**TECHNICAL MEMORANDUM NO. 1
SUPPLEMENTAL BASIS OF DESIGN - RESPONSE TO ECRB COMMENTS**

SUBJECT: Terminal 1, Latitude Project – Response to ECRB Comments

Reference: ENGEO; Existing Geotechnical Conditions and Seismic Slope Stability, Terminal One, Richmond, California; July 24, 2017; Project No. 5931.000.000

Site-Specific GM Analysis Plots

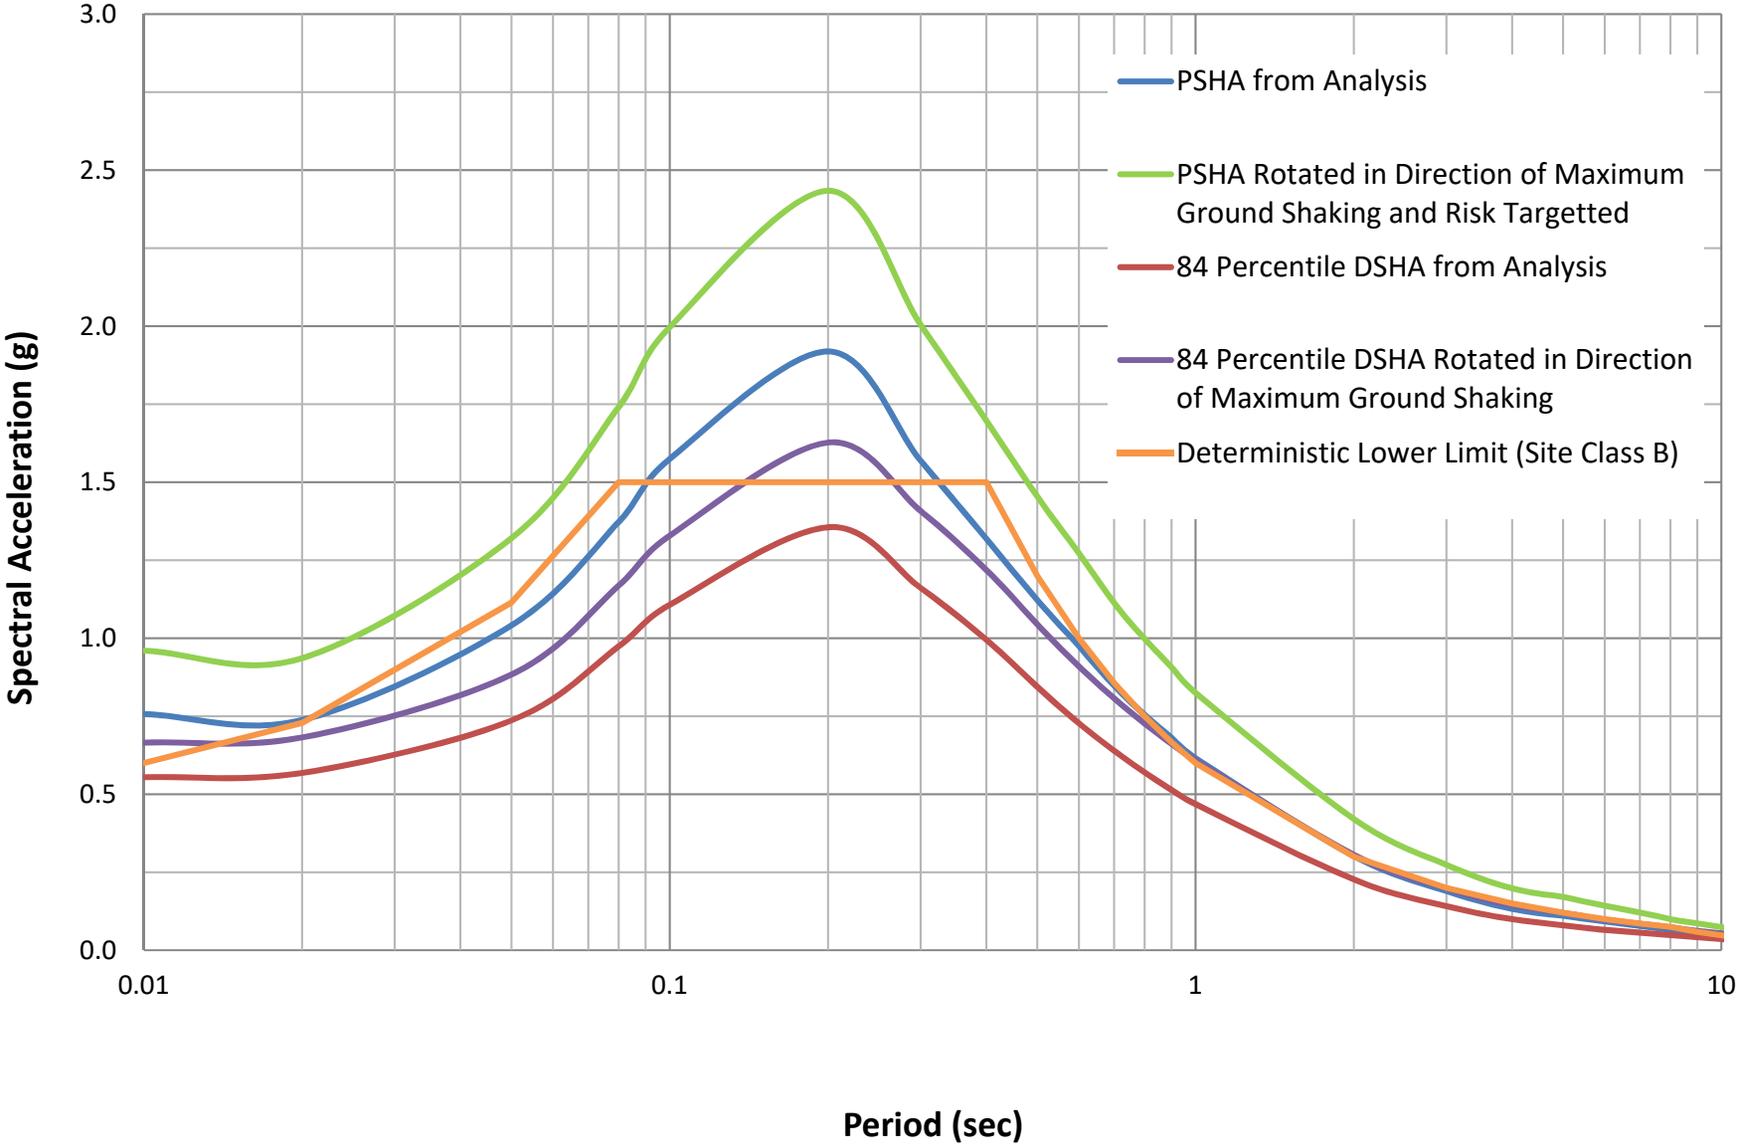
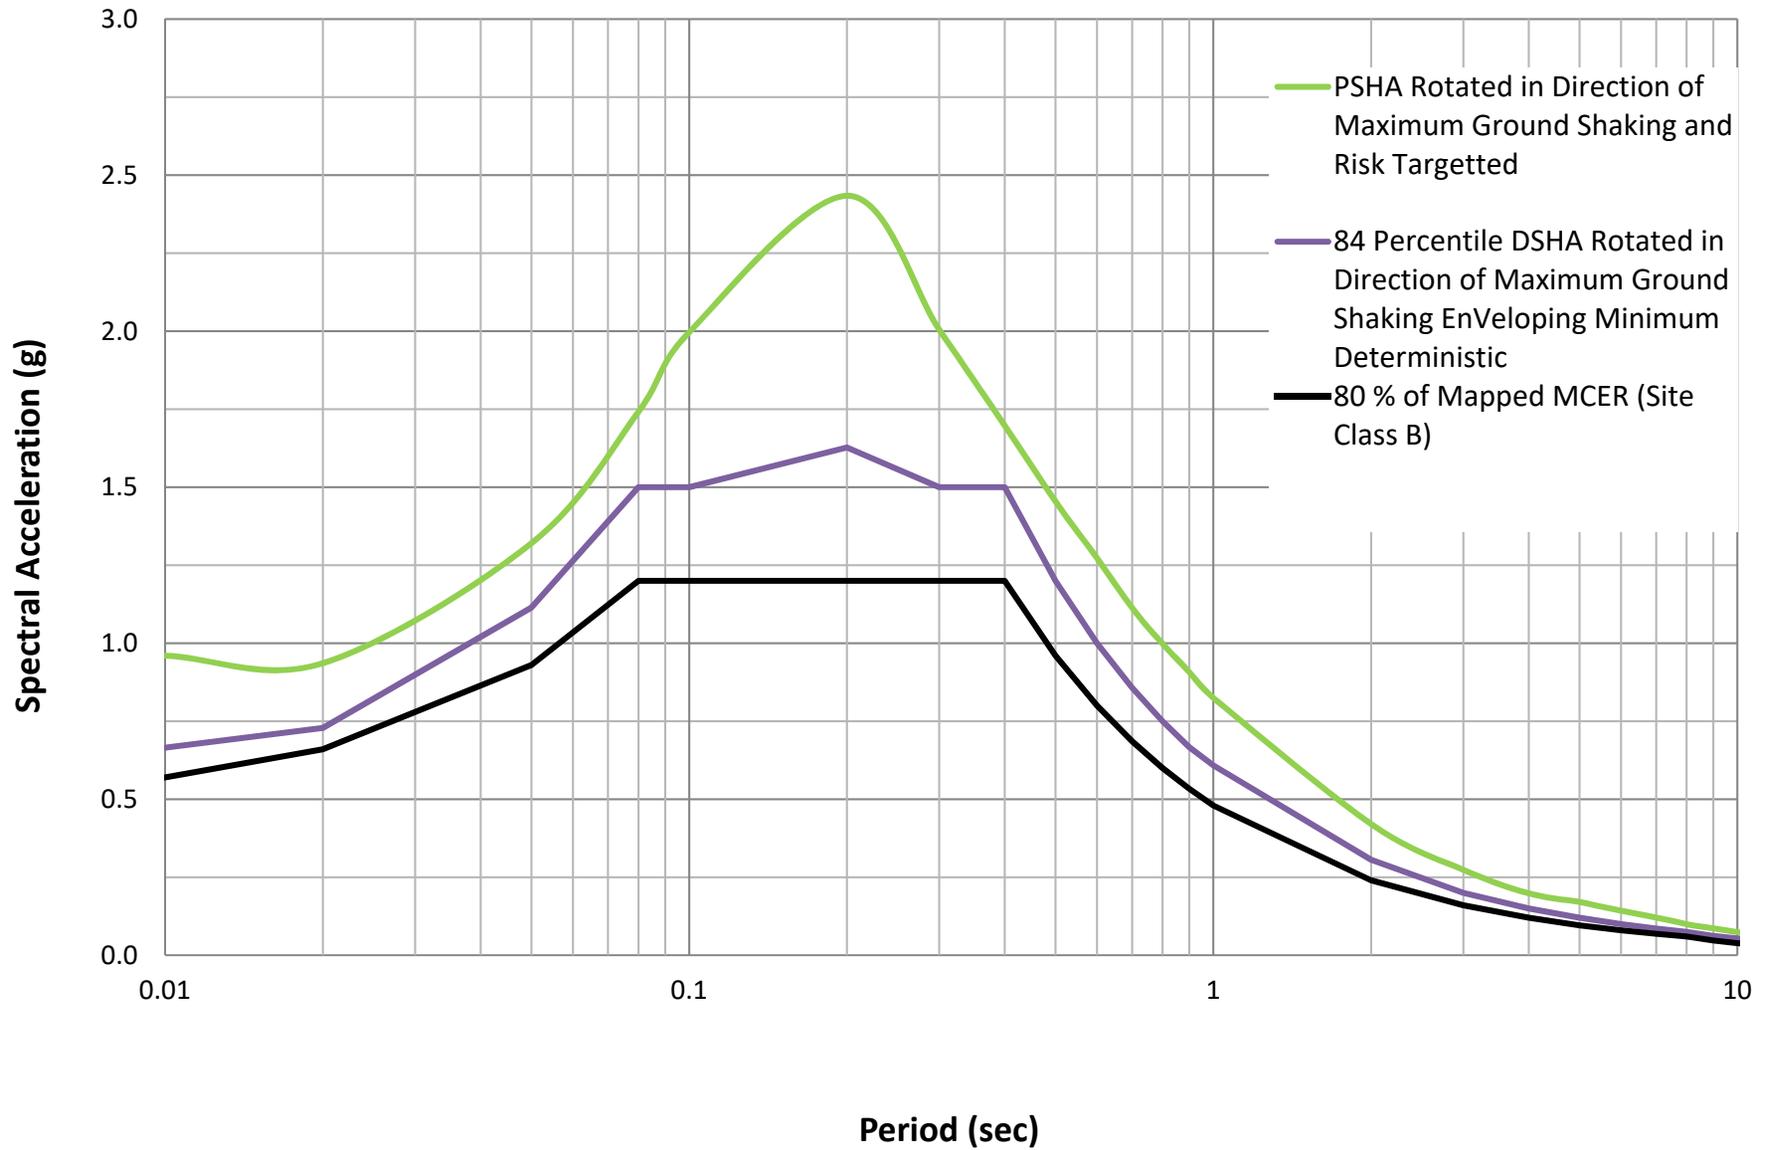
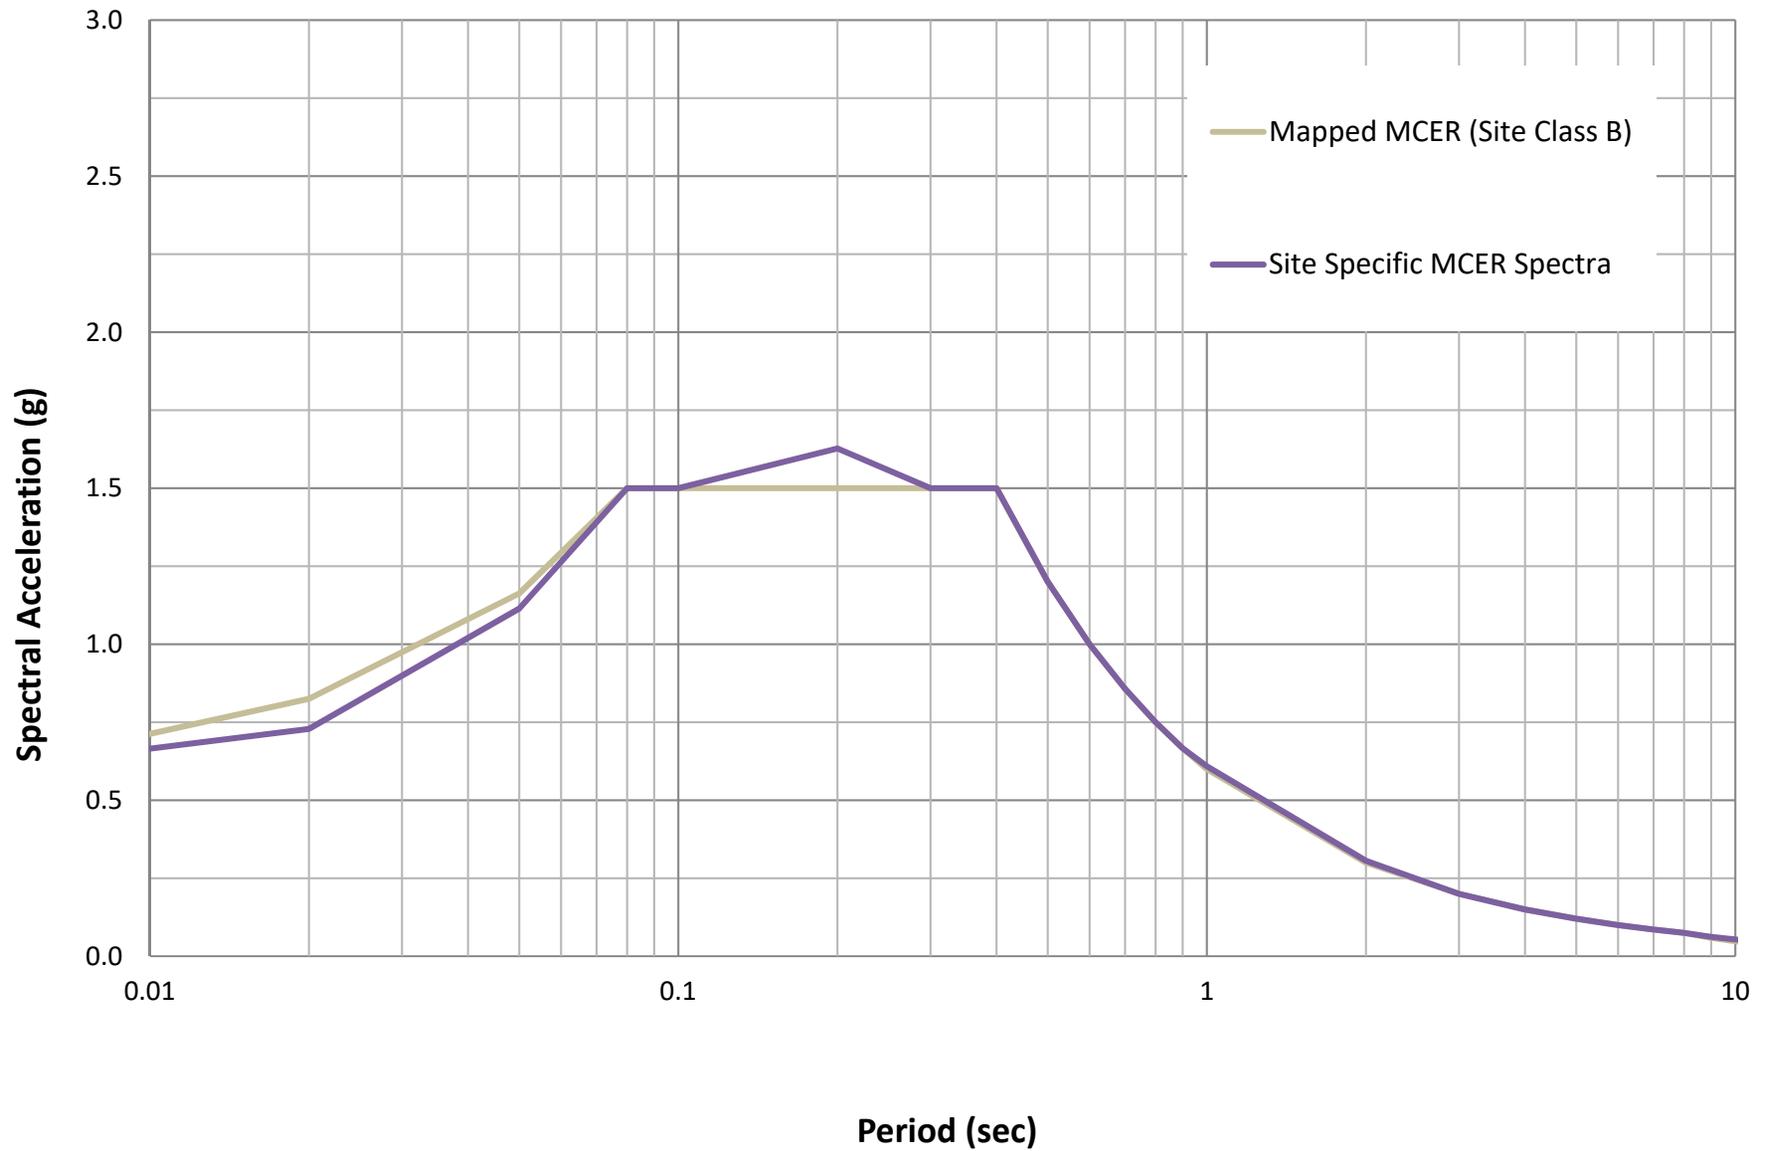
ECRB Comment #6:

Reexamine the results and provide a narrative of the seismic hazard staging.

We prepared the following narrative describing the analysis methodologies, reasoning, and assumptions for the site-specific ground response analysis. Specifically, we have addressed the decision making process for choosing the target base rock spectra (mapped MCE_R versus site-specific MCE_R) and selection of appropriate input rock ground motions to supplement the information in our referenced report.

We used the mapped Risk-Targeted Maximum Considered Earthquake (MCE_R) spectra corresponding with a Site Soil Class B to scale our input ground motions in our site-specific ground response analysis. ASCE 7-10, Section 21.1 states that the mapped MCE_R for a Site Soil Class B may be used as the target spectra when developing input rock motions for a ground response analysis. Furthermore, our experience indicates that in this area the mapped spectra is typically very similar to the spectra developed through site-specific seismic hazard analysis performed in accordance with ASCE 7-10, for Site Class B. To evaluate this effect and answer this question, we performed a site-specific seismic hazard analysis and provide our results compared with the mapped Site Soil Class B MCE_R spectra in Attachment B. As illustrated, the code specified deterministic lower limit governs the analysis and either matches or is less than the mapped Site Class B spectra at all periods except near a period of 0.2 seconds where the maximum rotated 84th-percentile deterministic seismic hazard results govern. Since the structural period of interest is 0.74 seconds, use of the mapped MCE_R for Site Soil Class B adequately captures the governing site response.
